Subdivision and Land Development Cover  
Page for SLD # 05-22

Project Name: Keith Catania

Address: 246 & 248 Hillcrest Avenue

**RE: Preliminary / Final Plan Review  
246 & 248 Hillcrest Avenue  
Whitemarsh Township, Montgomery County, PA  
S/LD # 05-22  
Our Project Number 2022-04048**

**GRADING/IMPROVEMENTS PLAN**

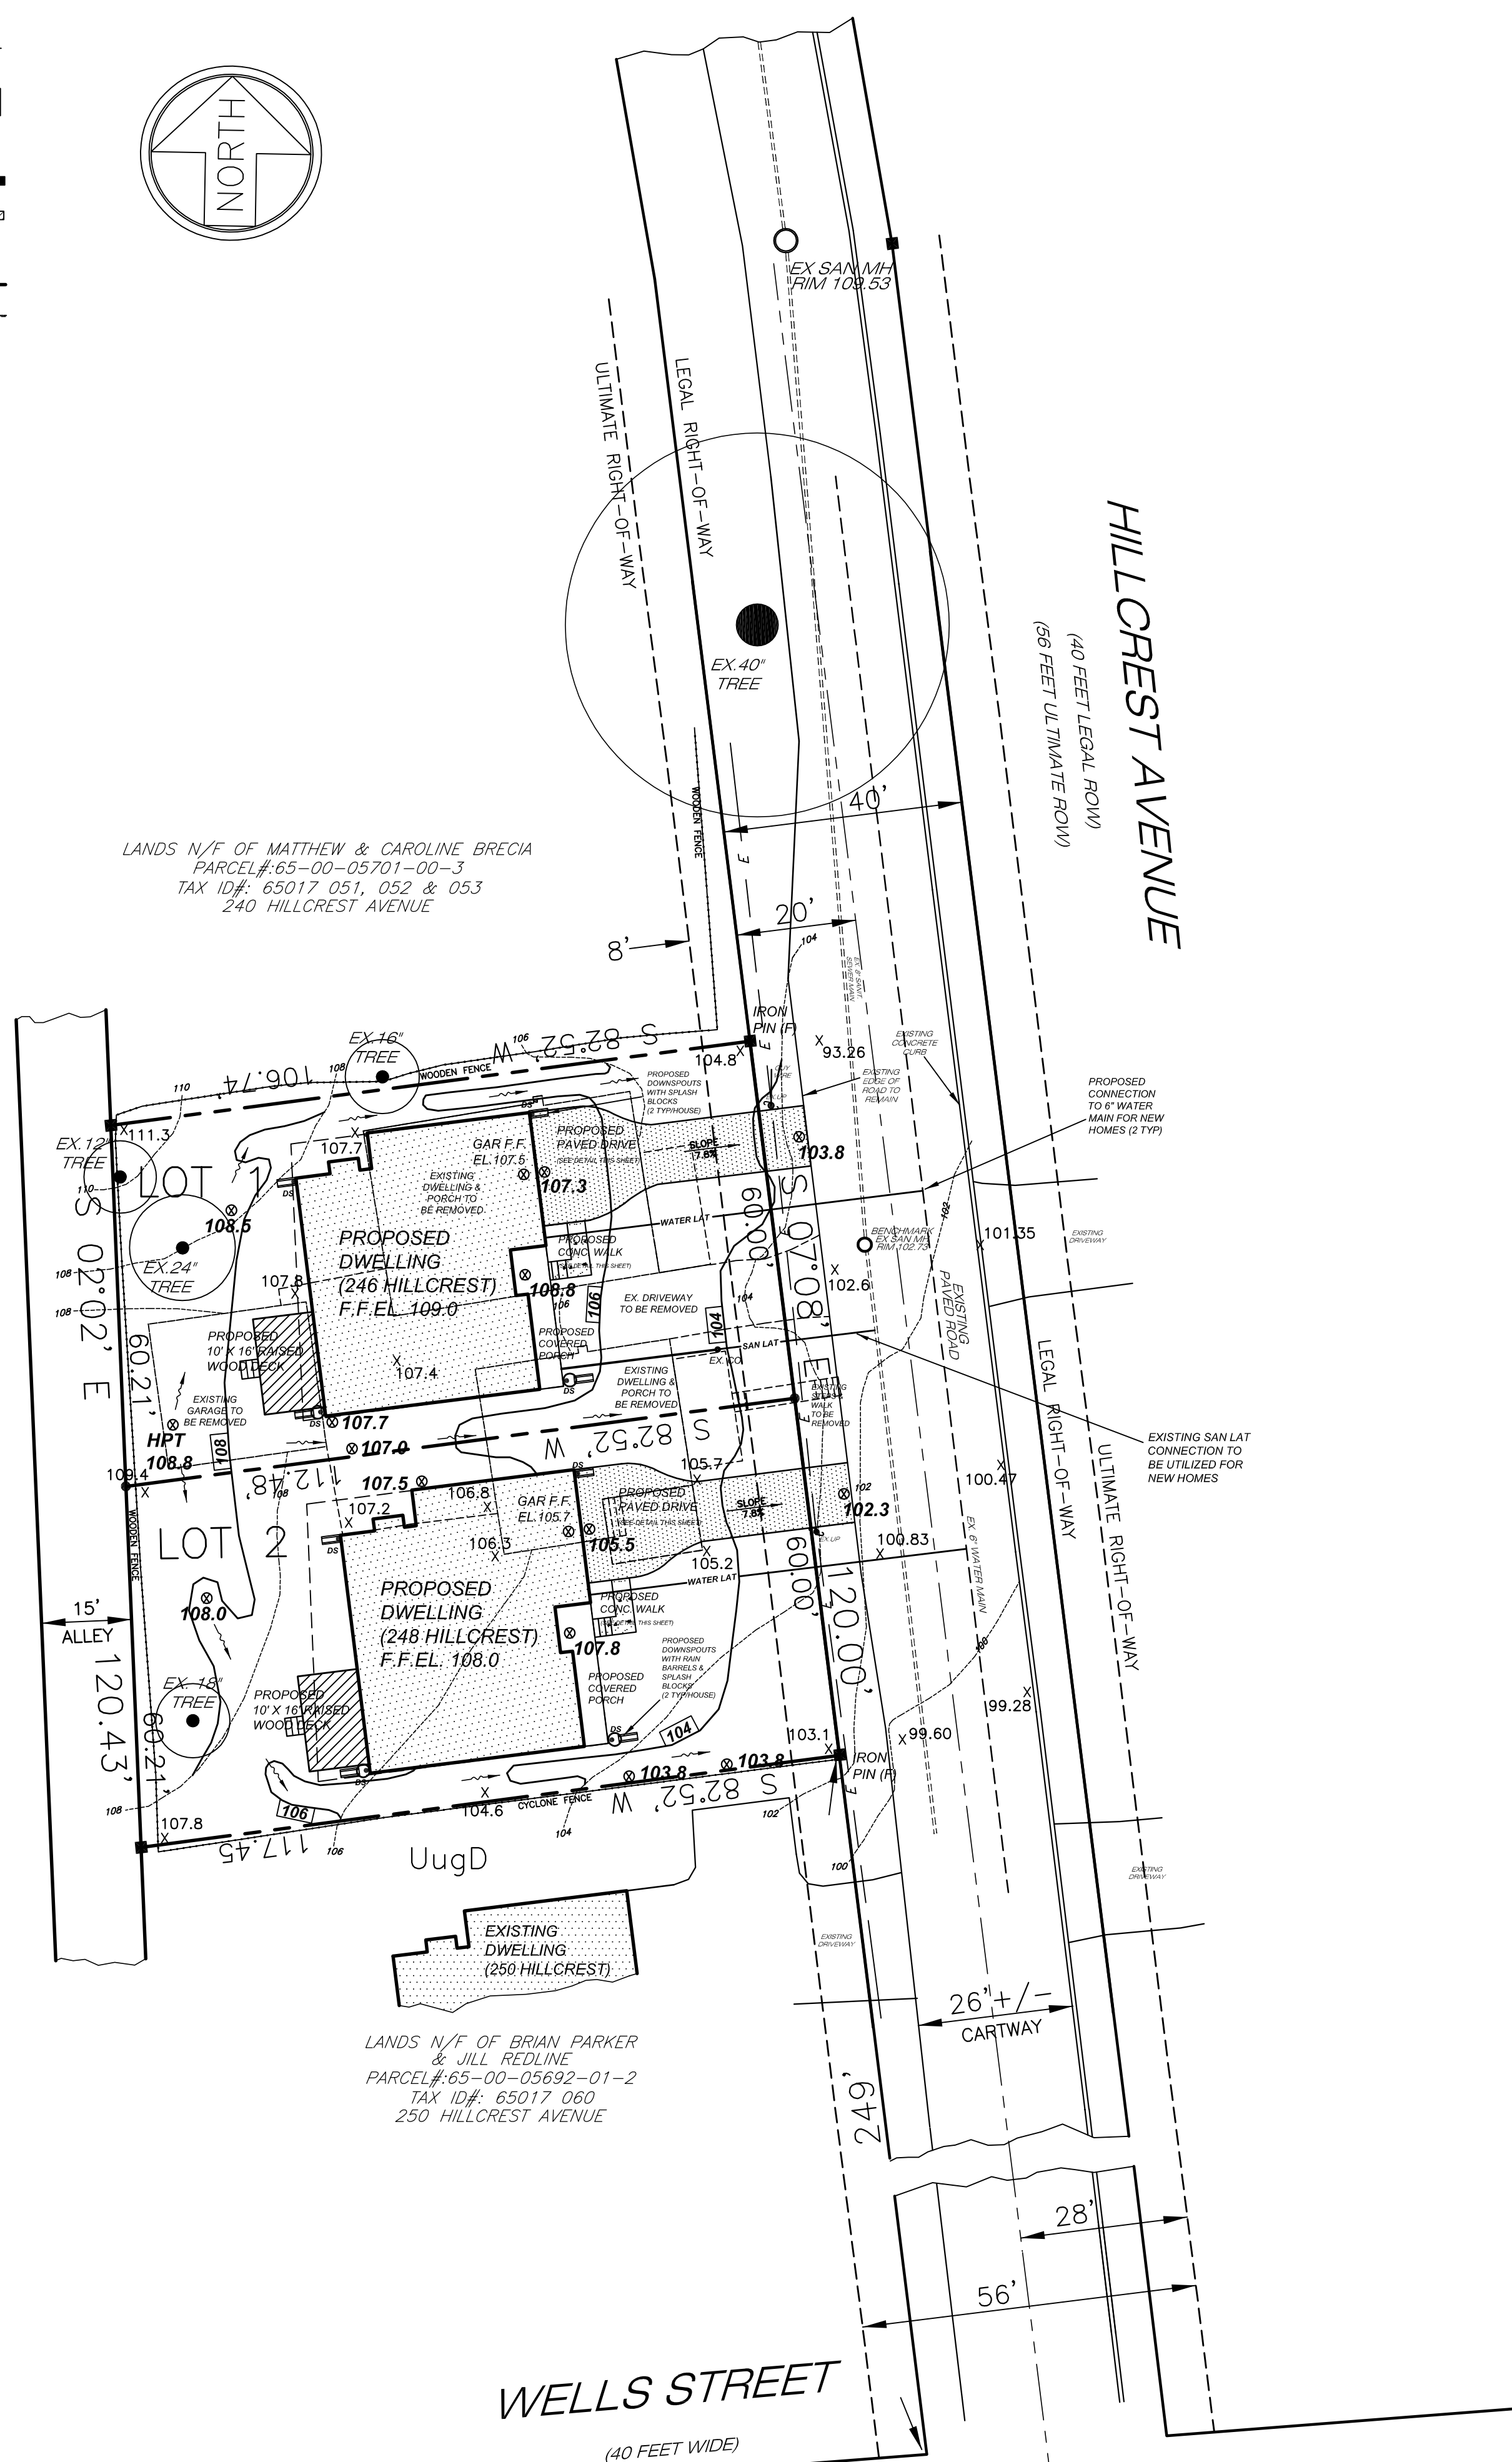
According to the submitted Grading Plan prepared by the applicant's engineer, it appears site grading may occur within the root zone of an existing mature tree (18" dbh) on proposed Lot 2. We advise you that the part of the root system in which construction activities should be avoided is known as the protected root zone. Only about half of the root system is under the tree canopy. Many tree roots extend beyond the dripline a distance equal to two or more times the height of the tree. The protected root zone should ideally extend beyond the tree canopy. The plans should be revised accordingly and the municipality should ensure that grading does not occur within this area in accordance with regulations established in the Township Code.

<u>Section</u>	<u>Description</u>
23.	55-4(A)(4)	The tree survey plan shall be reviewed by the Shade Tree Commission in a public meeting.
24.	55-4(B)(1)	Proposed grading must be revised so as not to fall within the drip line of existing trees to be preserved.
25.	55-4(B)(2)	A note must be added to the Construction Sequence on Sheet 4 requiring a pre-construction conference with the Township Shade Tree Commission prior to start of construction.

<u>Section</u>	<u>Description</u>
26. 58-4(B)(2)(k)	The proposed contour line representing an elevation of 108 does not appear to tie into existing contours in the area of a existing 24" tree at 246 Hillcrest Avenue, and must be revised.

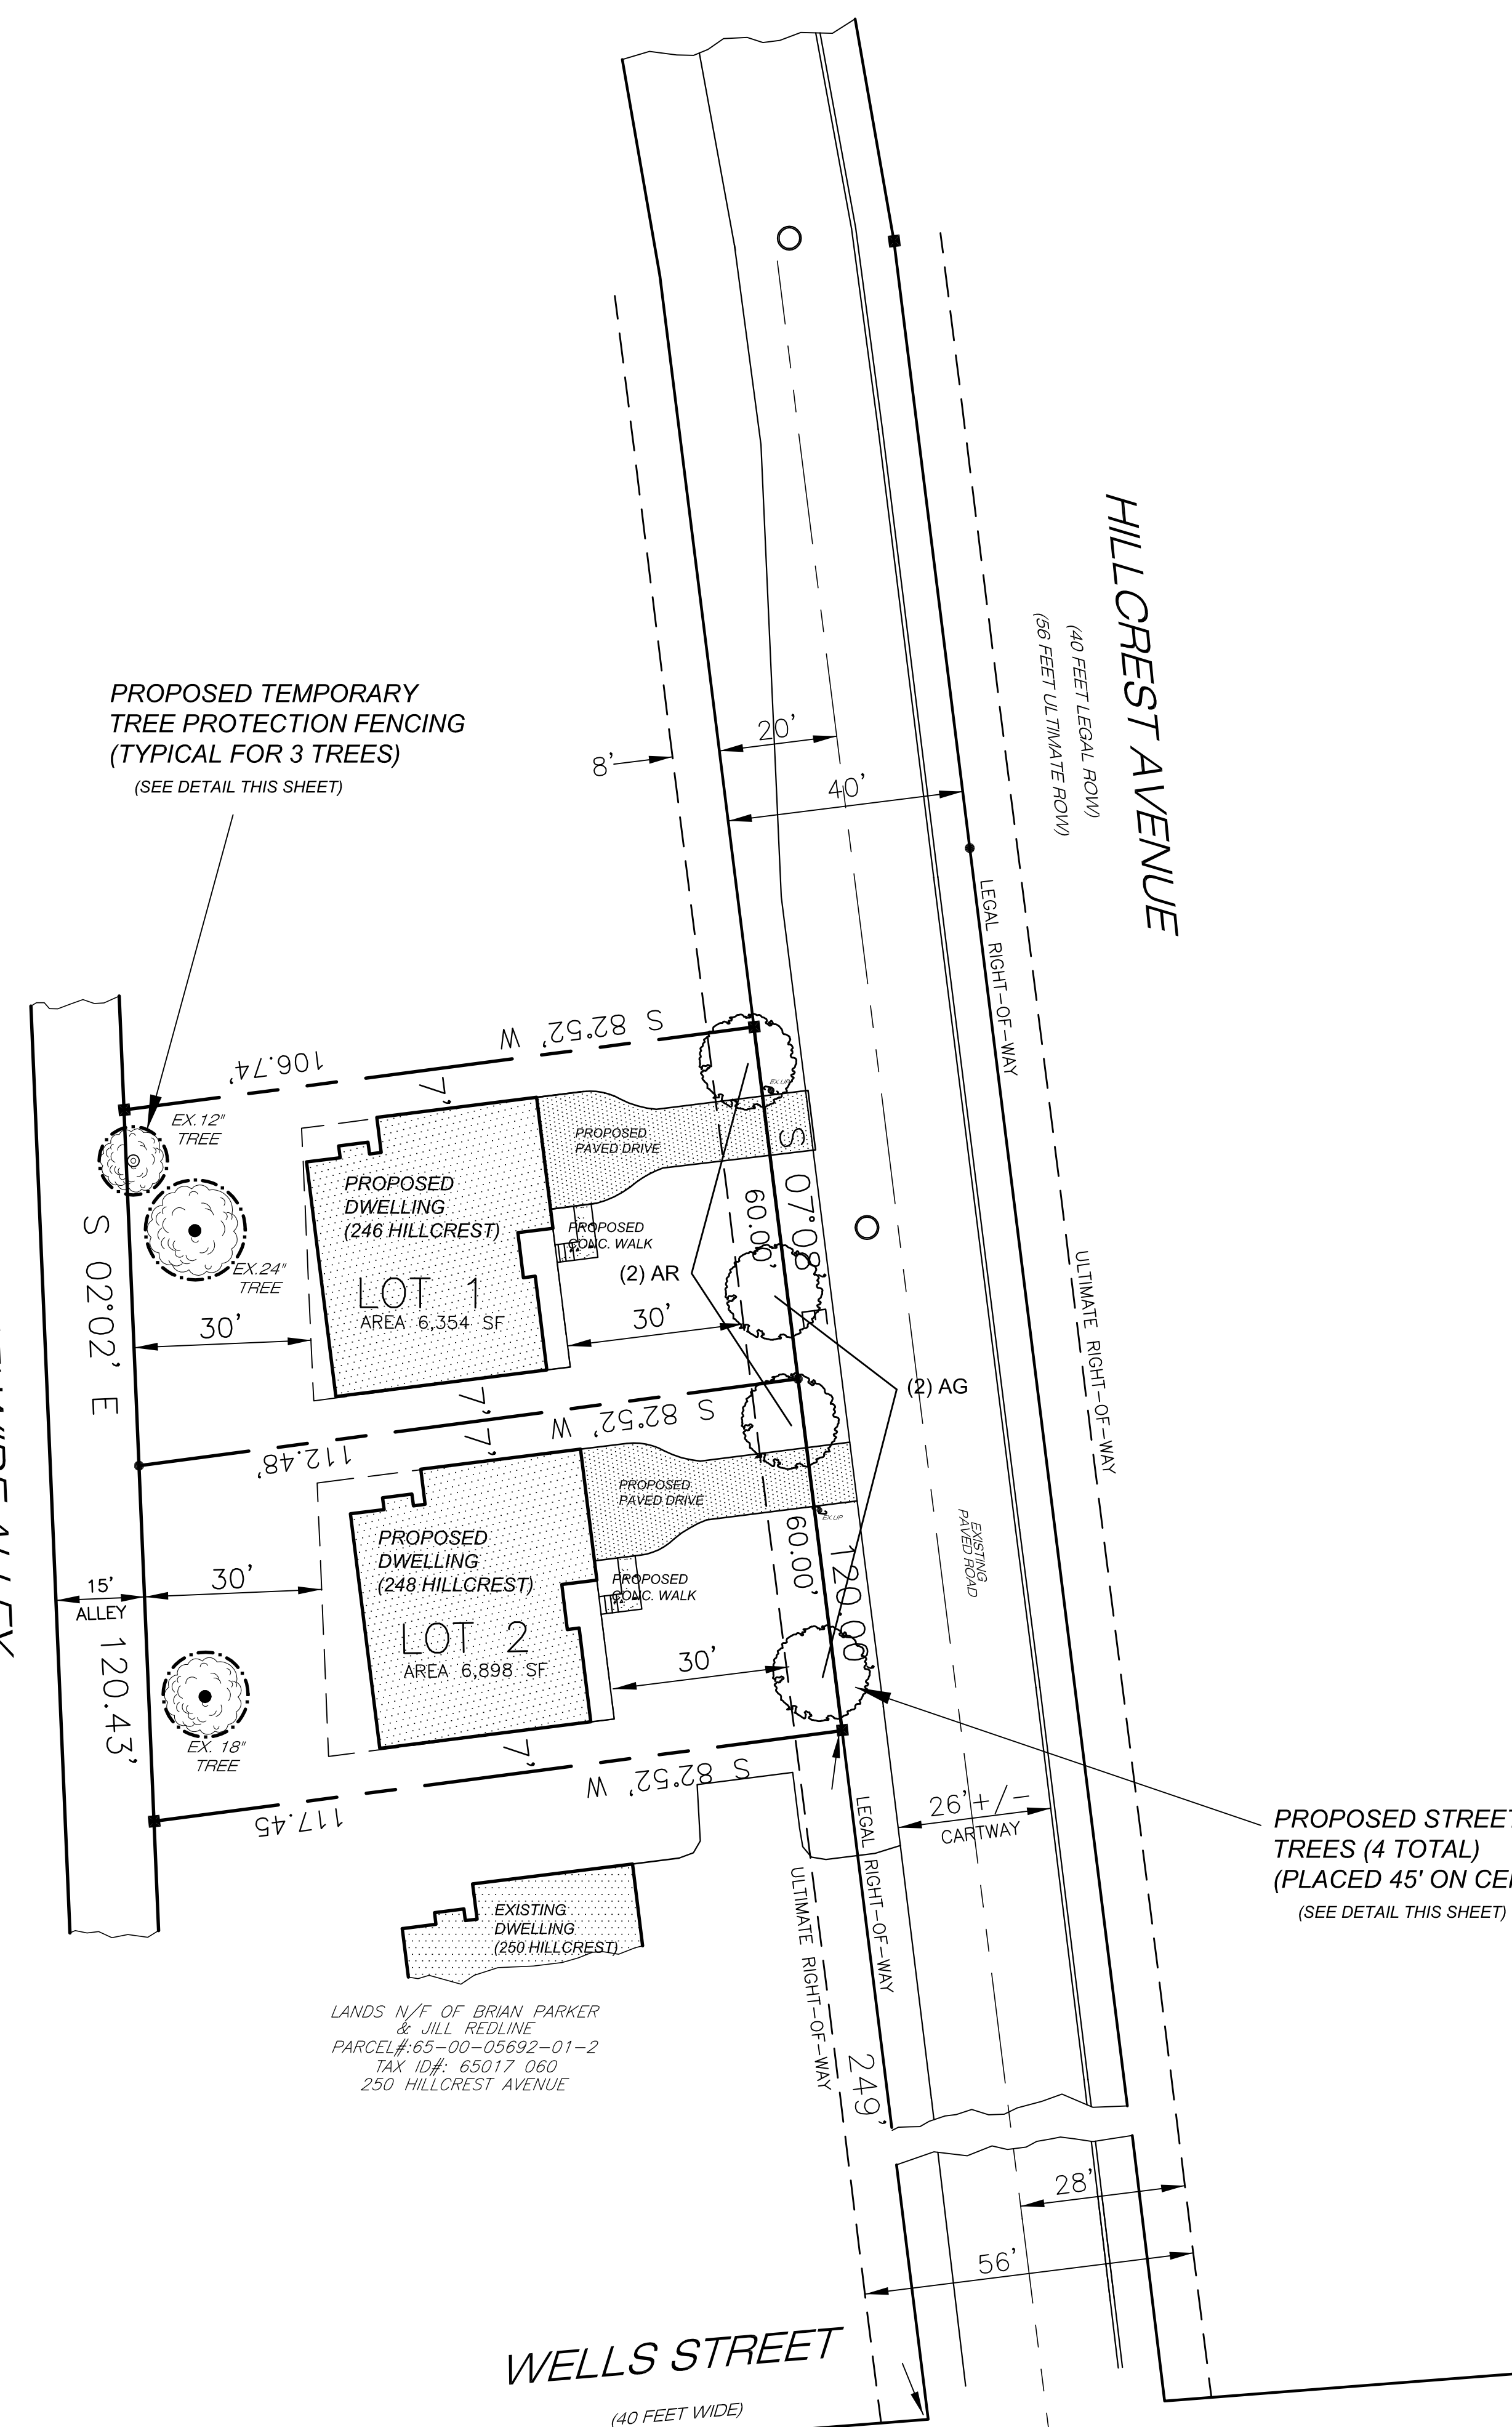
For the subject streetscape, I am fine with the *Acer rubrum* and *Acer ginnala*. Both hardy choices with seasonal interest. I want to make sure that the *A. ginnala* is of tree form as indicated on the plan. Please have the applicant make sure the planting area for the said trees, obtains some compost and soil amendments at the time of planting.
